PACIF Risk Management Report

Member: Richmond Town

Visit Date: 05/02/2023

Location: Playground & Related **Location Detail:** Volunteer Park - Plastic coating on the swings.

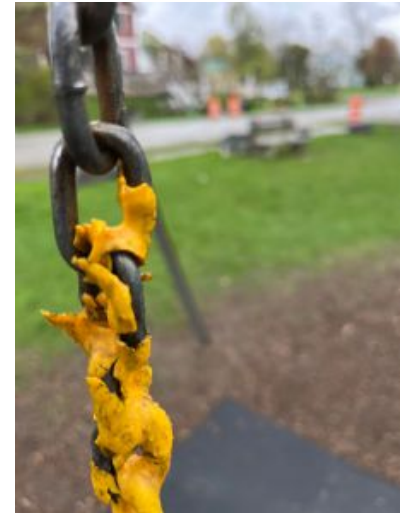
Issue: Sections of wooden play equipment exhibited sharp corners, were rough or had splinters present.

Recommendation: Sharp points, corners, or edges on any part of the playground or playground equipment may cut or puncture a child's skin. Plastic play elements must be regularly maintained to eliminate the potential for cuts.
